Access Compliance Report

Public Rights-of-Way

(Curb Ramps)

Intersection ID: 12413	Main Street: N_BREVARD_ST	Cross Street: E_6TH_ST	Location: W
ADA ID: AAEA12A9A78E	Ramp Type: Perp	Initial Pass/Fail: Pass	Overall Compliance: No
Severity Score: 5			
Codes/Mitigation Info/Possible Solution		Field Measurements/Component Compliance

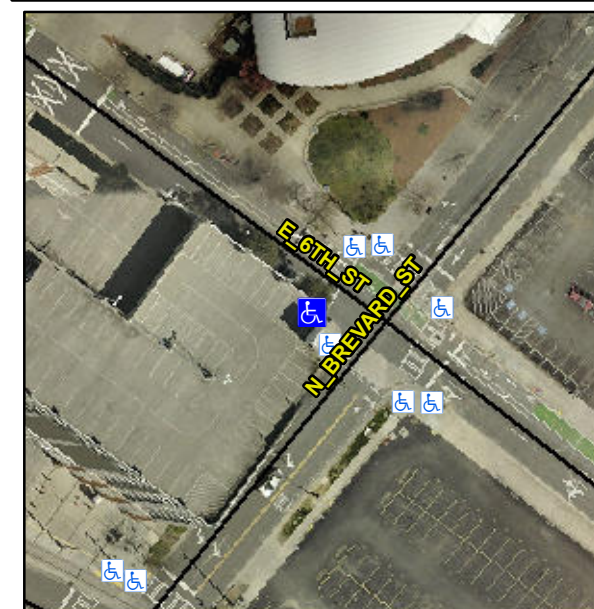
Not Found, R304.5.4

Compliance	Description	Data	Compliance	Description	Data
N/A	Ramp Length (in)	90.0	Yes	Ramp Slope (%)	8.1
Yes	Ramp Width (in)	48.0	Yes	Ramp XSlope (%)	0.8
N/A	Flare Type LT	Sloped	N/A	Flare Type RT	N/A
N/A	Flare Slope LT (%)	4.5	N/A	Flare Slope RT (%)	9.7
N/A	Flare Traversable LT?	Yes	N/A	Flare Traversable RT?	No
Yes	Landing Length (in)	48.0	Yes	DWS Provided?	Yes
Yes	Landing Width (in)	48.0	Yes	DWS Contrast?	Yes
Yes	Landing Slope (%)	0.6	Yes	DWS Length (in)	24.0
Yes	Landing X Slope (%)	0.6	Yes	DWS Full Width?	Yes
N/A	Landing Curb? (Y/N)	No	Yes	DWS Offset (in)	1.5
N/A	Shared Landing?	No			
Yes	Gutter Ponding?	No	No	Gutter Slope (%)	5.2
Yes	Gutter Lip Ht (in)	0.0	Yes	Gutter X Slope (%)	0.1
N/A	Painted X Walk1?	Yes	N/A	Painted X Walk2?	N/A
	X Walk 1 Direction	To NE		X Walk 2 Direction	N/A
N/A	X Walk 1 Width (in)	112.0	N/A	X Walk 2 Width (in)	N/A
	X Walk 1 Slope (%)	2.2		X Walk 2 Slope (%)	N/A
	X Walk 1 X Slope (%)	0.3		X Walk 2 X Slope (%)	N/A

Yes	Ramp inside XWalk1?	Yes	N/A	Ramp inside XWalk2?	N/A
	Road Slope (%)	N/A	N/A	Clear Space?	Yes
	Road X Slope (%)	N/A	N/A	Clear Space to XWalk (in)	N/A
Yes	Any Obstructions?	No	Yes	Storm Grate/Utility Hazard?	No
	Obstruction Type			Storm Grate/Utility Type	
		N/A			N/A
		Yes		Surface Condition? (G/P)	Good

**Remove & Replace Entire Ramp.
Remove & Replace Gutter.**
